From: [Annette LaMond](#)
To: [Strysky, Alexander \(EEA\)](#)
Subject: Comment Letter (EEA No. 15278)
Date: Friday, February 09, 2018 10:09:57 AM

I am writing to comment on MassDOT's Draft Environmental Impact Report (DEIR) for the Allston I-90 Interchange Improvement Project (issued on November 30, 2017). I have been following the discussion of the Allston I-90 project closely. I have attended four of MassDOT's public meetings, read the documents posted on the MassDOT website, and visited the Cambridge Public Library to review the DEIR. My comments are also informed by my 40-plus years as a Cambridge resident.

Re: Allston I-90 Interchange DEIR

At-grade Concept for the south shore of the Charles River adjacent to Boston University ca. 10/29/15

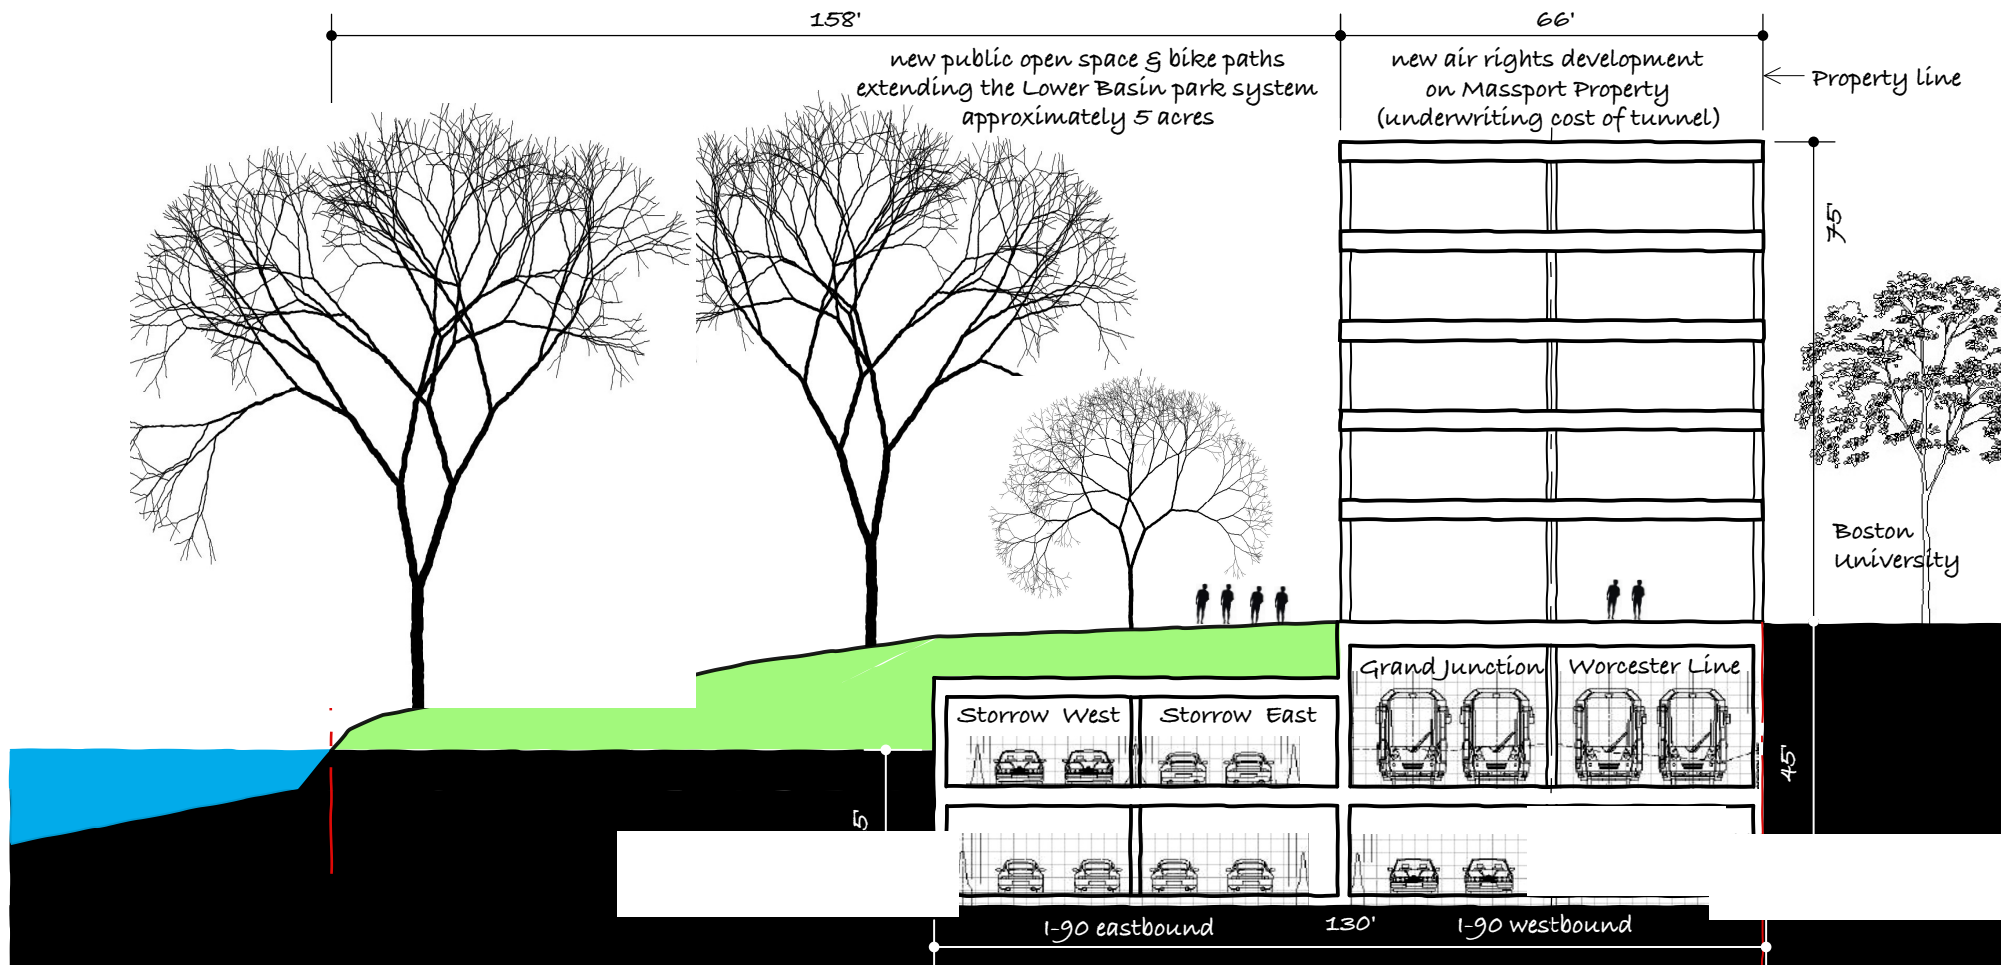
The only discussion of a tunnel option I have found in the entire 8 year process is contained in the presentation for Task Force Meeting #4, on June 25, 2014, where there is a single drawing, not drawn to scale, with a list of bullet points itemizing reasons for rejecting it. No costs are provided, no benefits are identified and, not least, any revenue streams that might offset the costs over the decades this plan will be in place. It appears this "review", such as it was, was little more than a "straw man" to be dismissed at the earliest opportunity.

Beyond the issue of the throat and the river connections, there are a number of other critical omissions from the study process and DEIR. We are told that Beacon Park Yard must provide layover facilities for 8 trainsets, to support stub-end rail operations at South Station. We are not told that the North South Rail Link project, currently being studied by MassDOT, would reduce the need for these layovers, and greatly expand the potential sites where they could be accommodated. BBELL-2
